**IHL# 201-259**  
**Upgrades & Renovation Poultry Processing Facility & Incinerator Shed**  
**Alcorn State University**  
**Lorman Campus**  
**Project Number: 2021-002**

**Addendum No. 2**

09October2023

CD-100

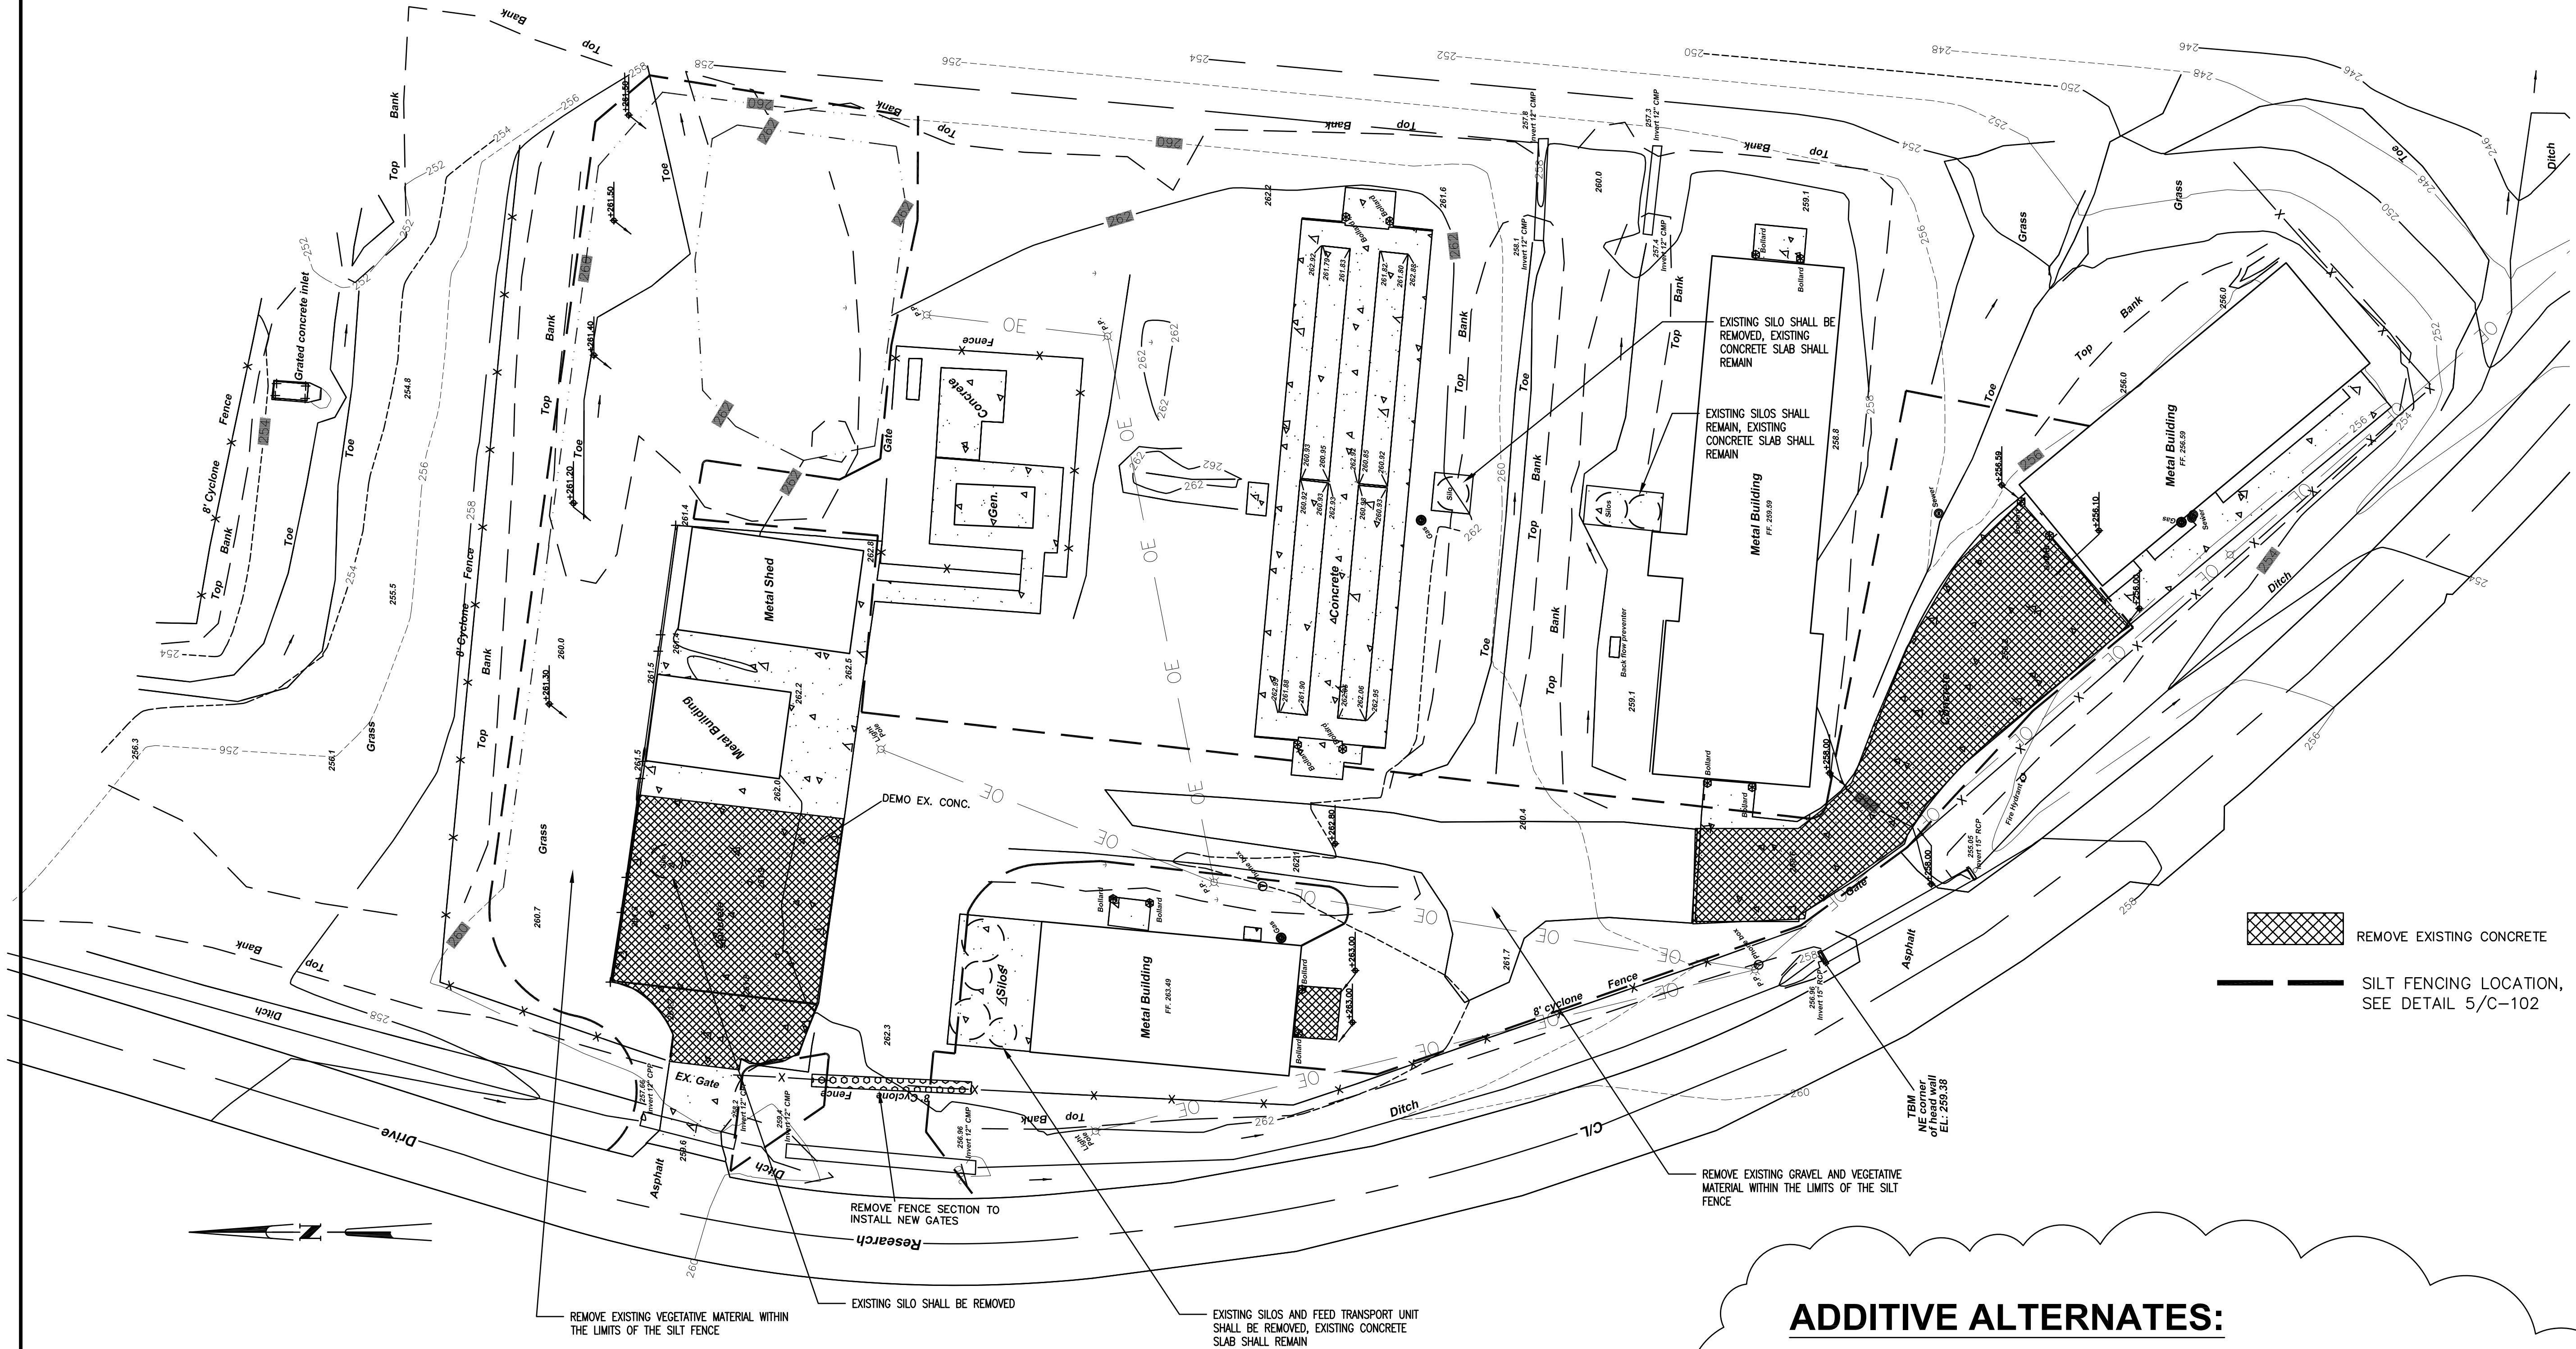
- Item No. 4      Clarification: See attached sheets CD-100 & C-101. All typical sitework relative to the grubbing & removal of vegetative material, removal of existing concrete & gravel shall be associated with Additive Alternates 1 & 2 as noted on sheets CD-100 & C-101.

**AS-101**

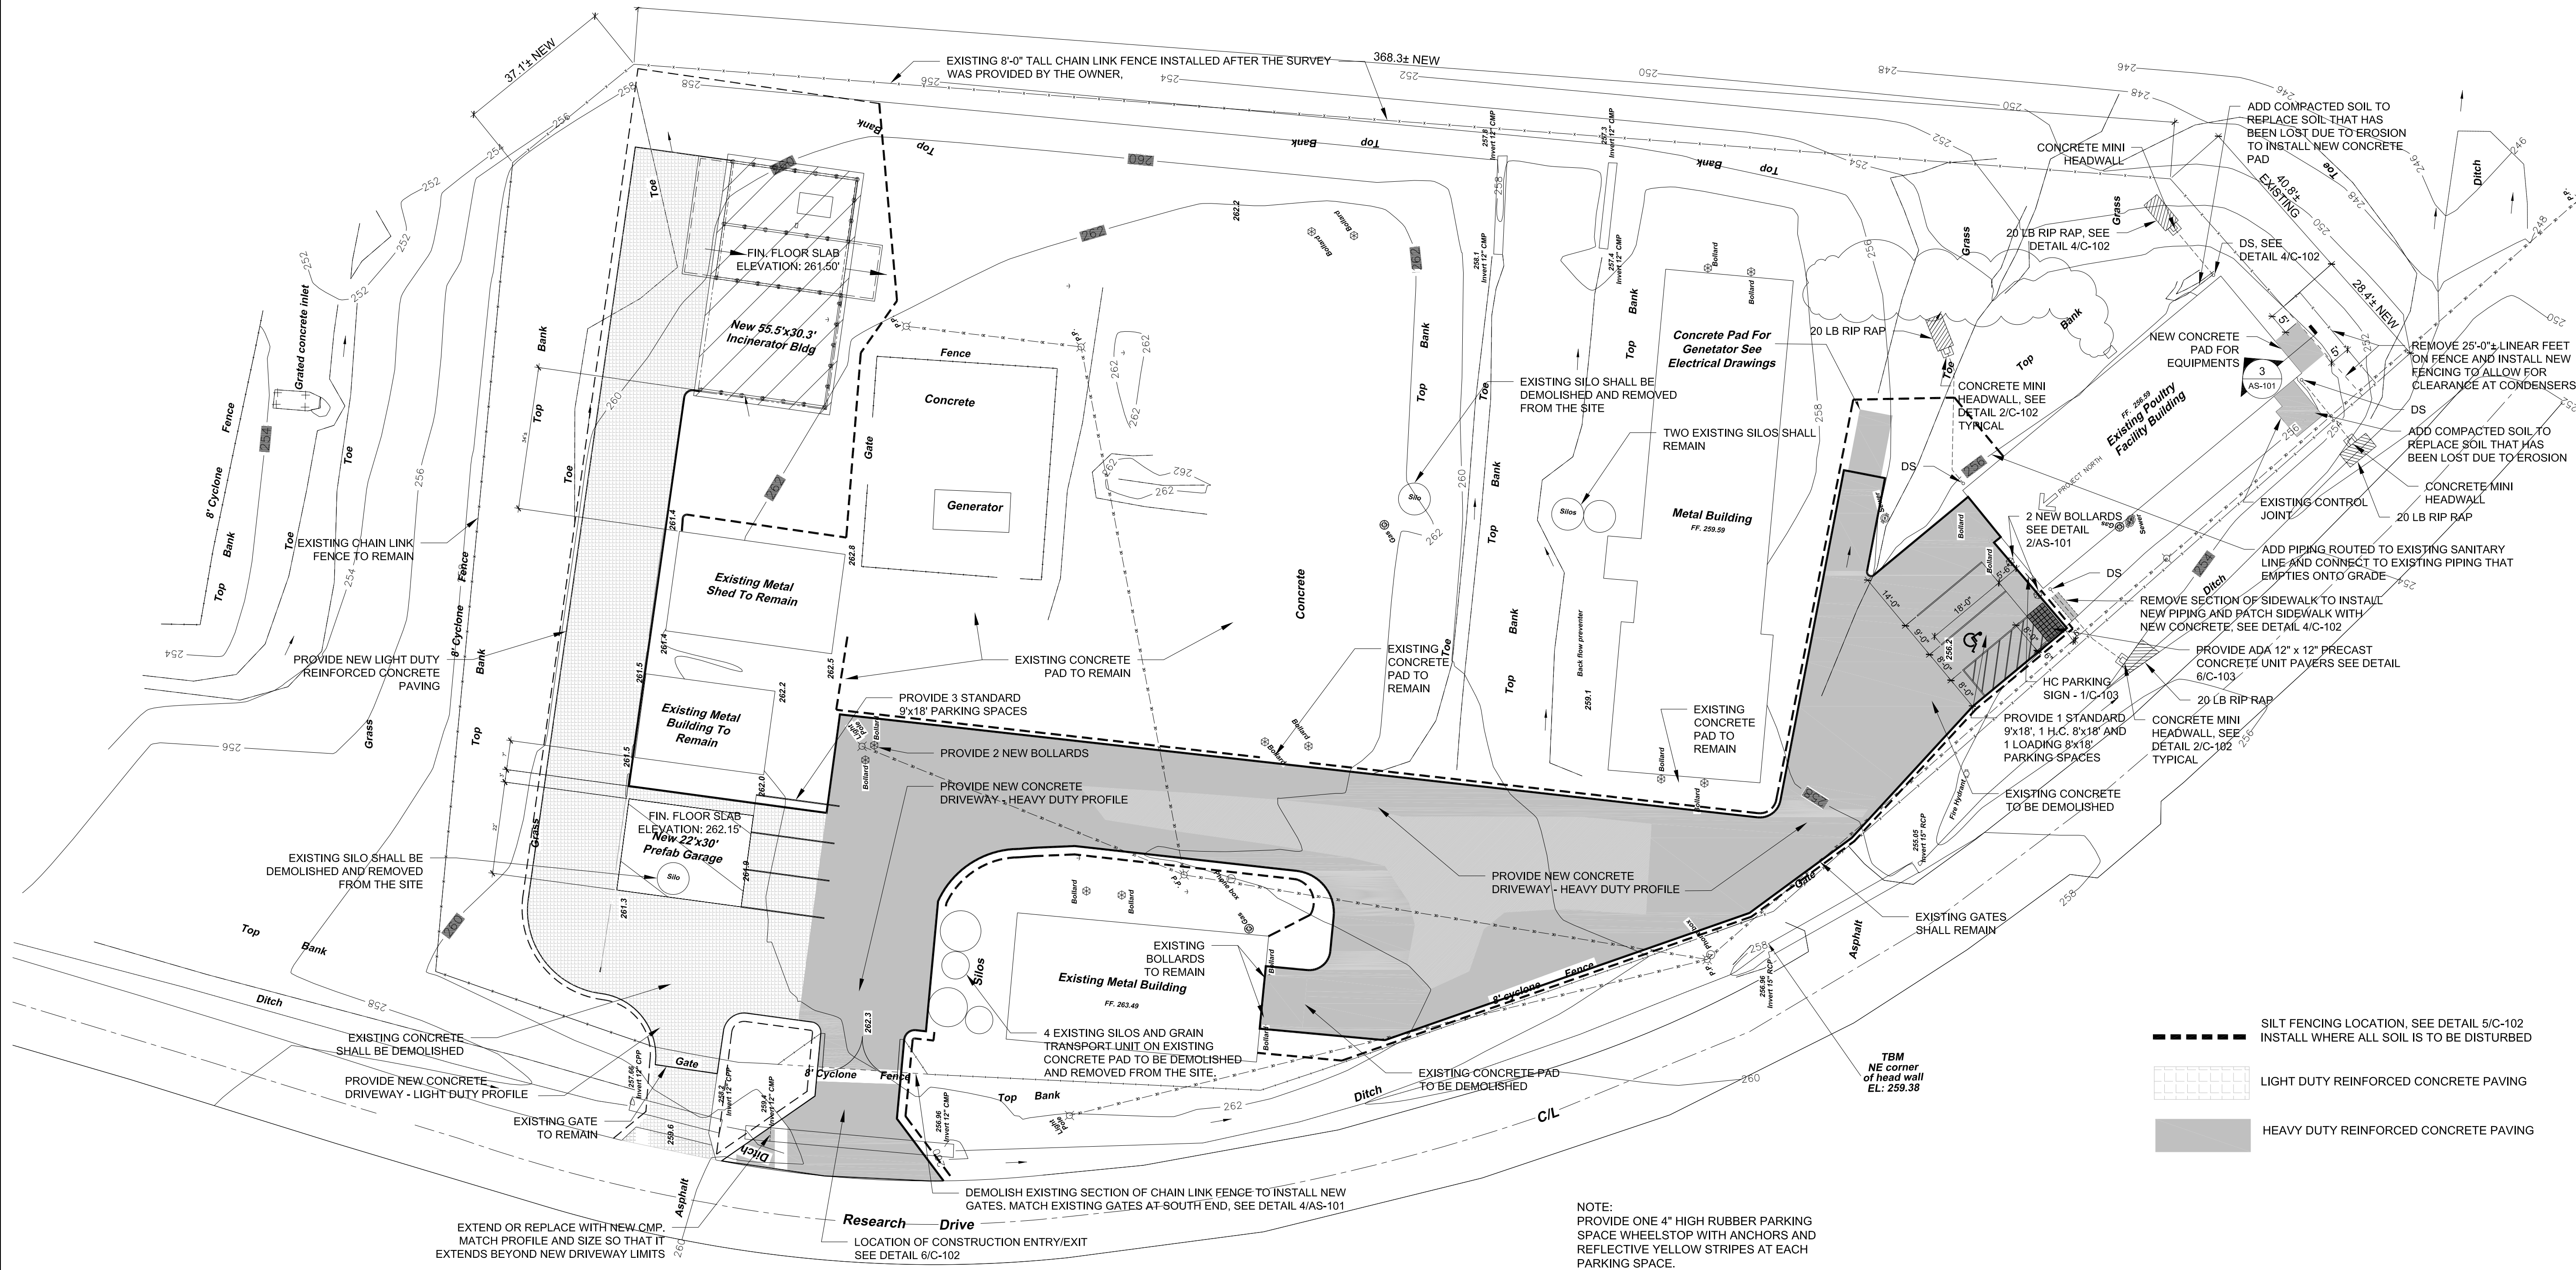
- Item No. 2      Delete note on attached sheet AS-101 – “Replace Damaged Grease Trap Unit. Replace Damaged piping and/or connections”. See drawing sheets PD-101 & P-101 which addresses the removal and replacement items of the existing damaged grease trap.

- Item No. 5      Clarification: The majority of the new earthwork is associated with the installation of the proposed new concrete drives and the incinerator shed. There is minor work around the existing pre-engineered metal building associated with storm water runoff via the downspouts (sheets C-102 & AS-101), plumbing and HVAC condenser units.

Drawing Title  
POULTRY DEMOLITION FLOOR PLAN

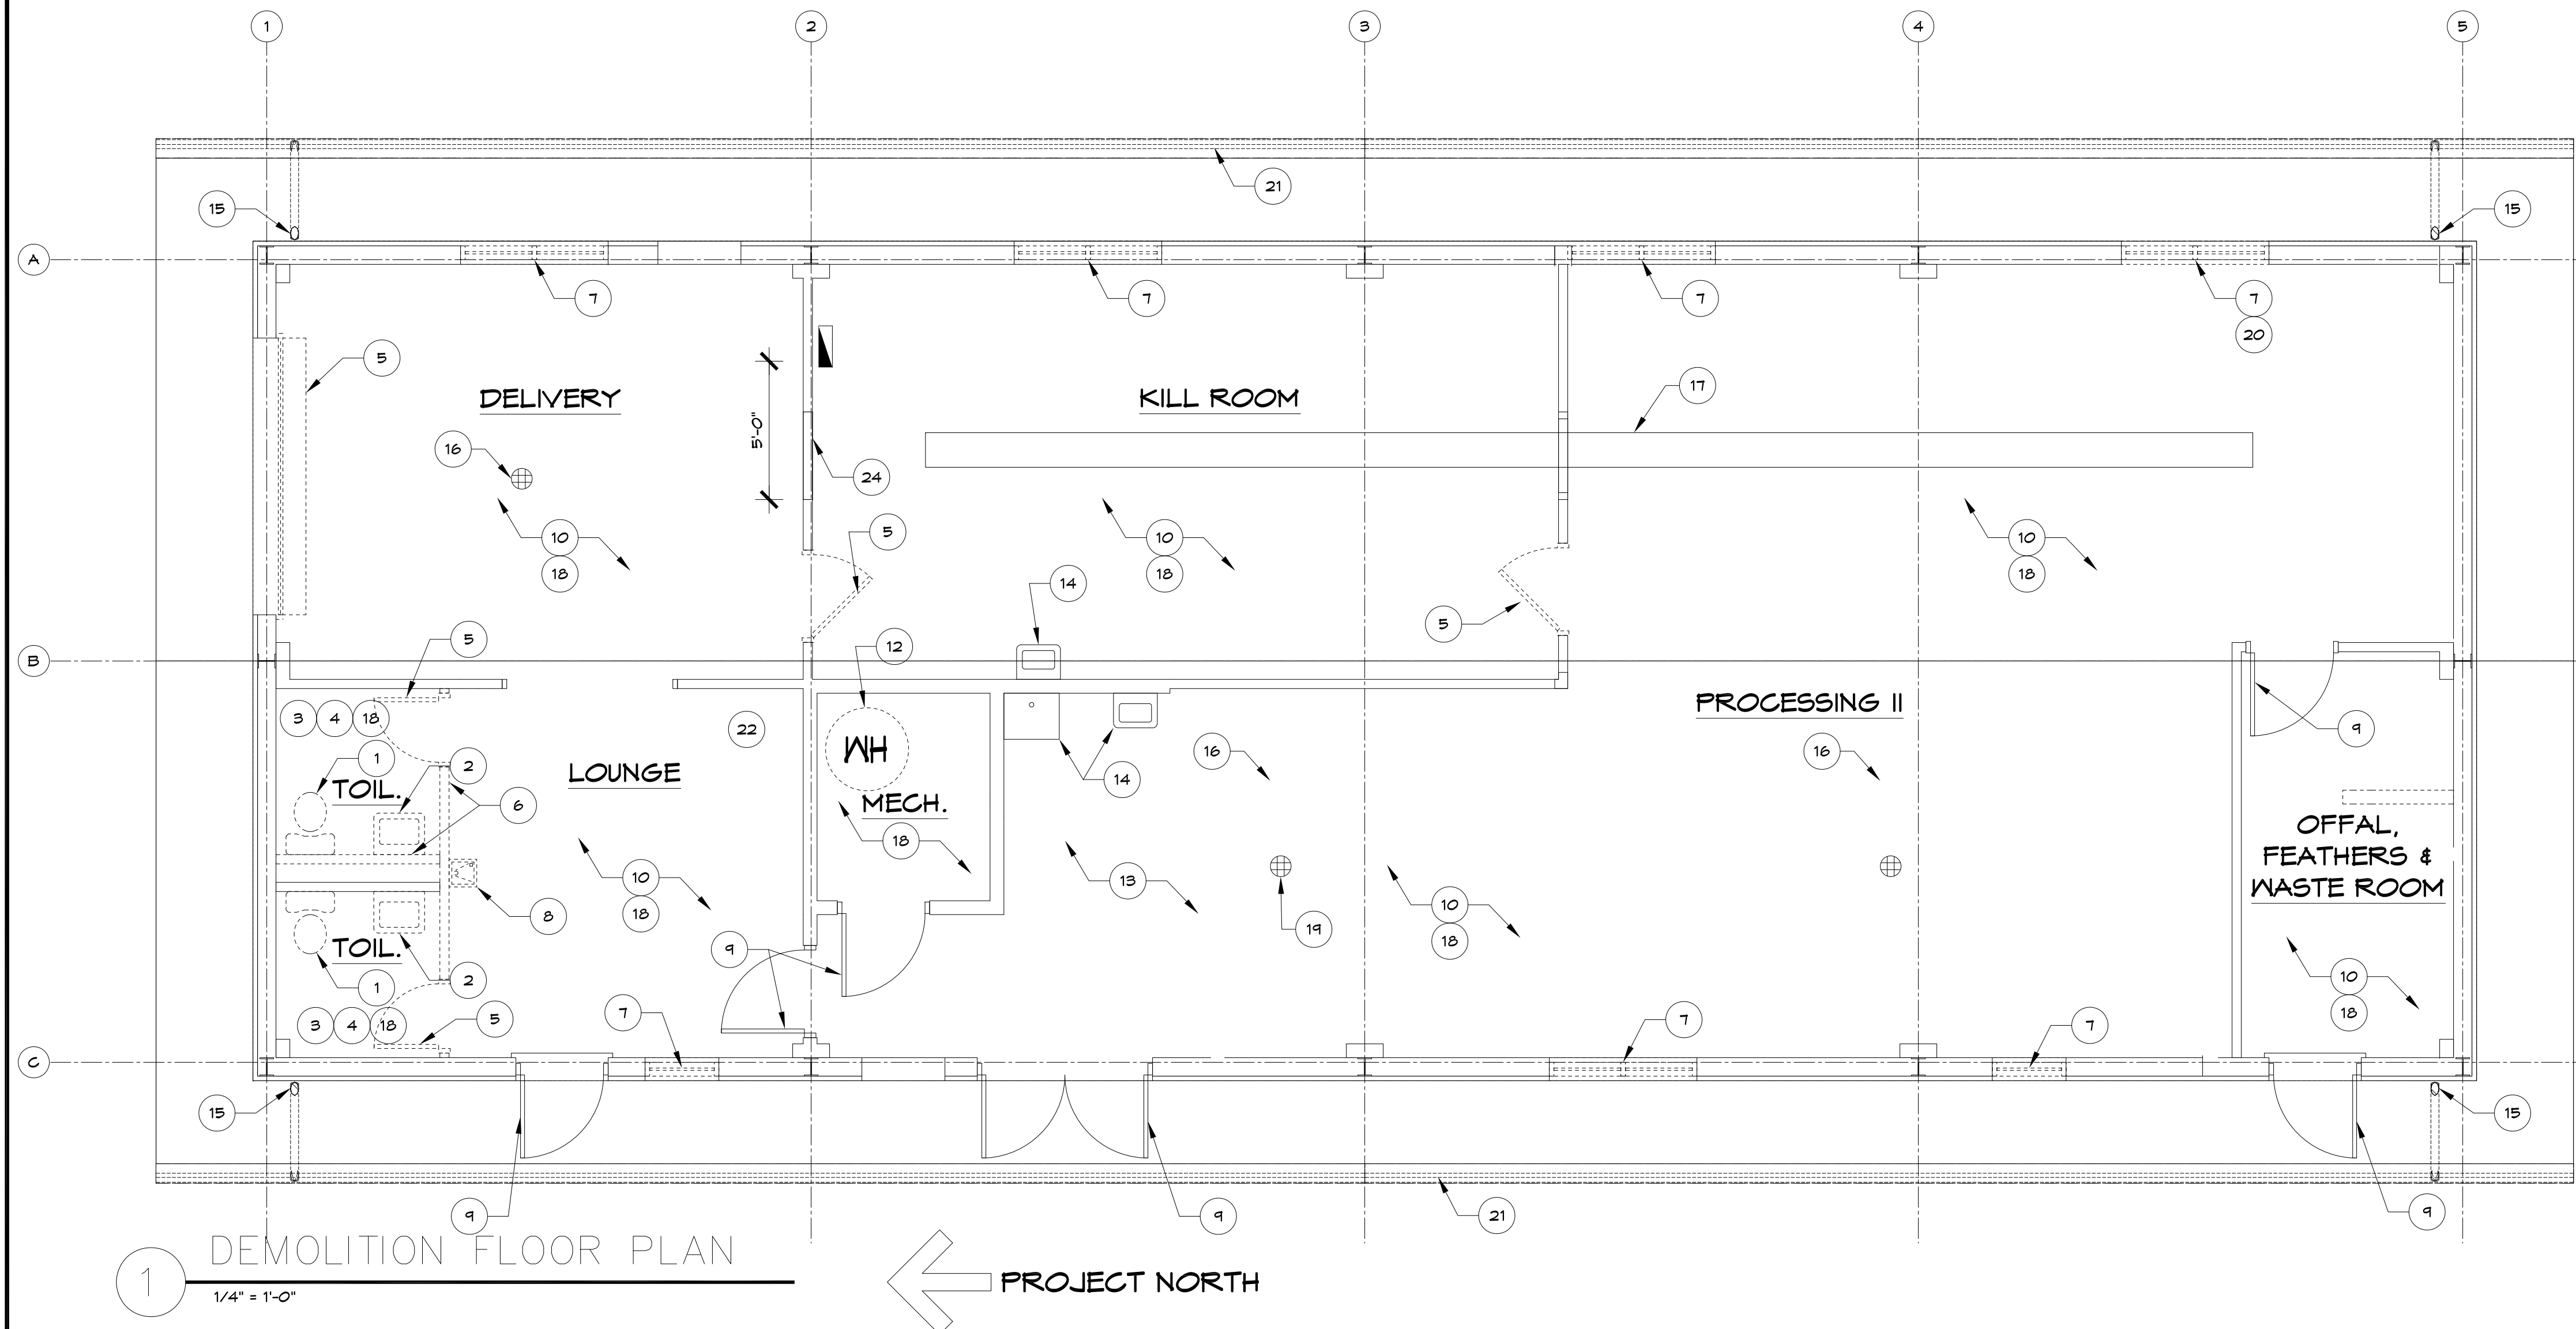
- Item No. 3      Remove a section of the existing 4” CMU partition along column line 2 to remove existing poultry processing equipment and install the new equipment. Replace the demolished a section of the partition using with new 4” CMU after the equipment has been moved into the Kill Room.

- REMOVE ALL EXISTING POULTRY PROCESSING EQUIPMENT AND LOOSE FURNITURE AND DISPOSE OF PER STATE REGULATIONS.
- REMOVE A 5'-0" SECTION OF 4" THICK CMU BETWEEN THE EXISTING DELIVERY ROOM & KILL ROOM TO FACILITATE THE REMOVAL OF THE EXISTING POULTRY PROCESSING EQUIPMENT AND THE INSTALLATION OF THE NEW EQUIPMENT. ONCE THE EQUIPMENT (STILL IN BOXES) IS PLACED IN THE KILL ROOM INSTALL NEW 4" THICK CMU TO REPLACE THE DEMOLISHED MATERIAL. THE CONFIGURATION SHOULD MATCH THE ORIGINAL INCLUSIVE OF THE CONVEYOR OPENING.
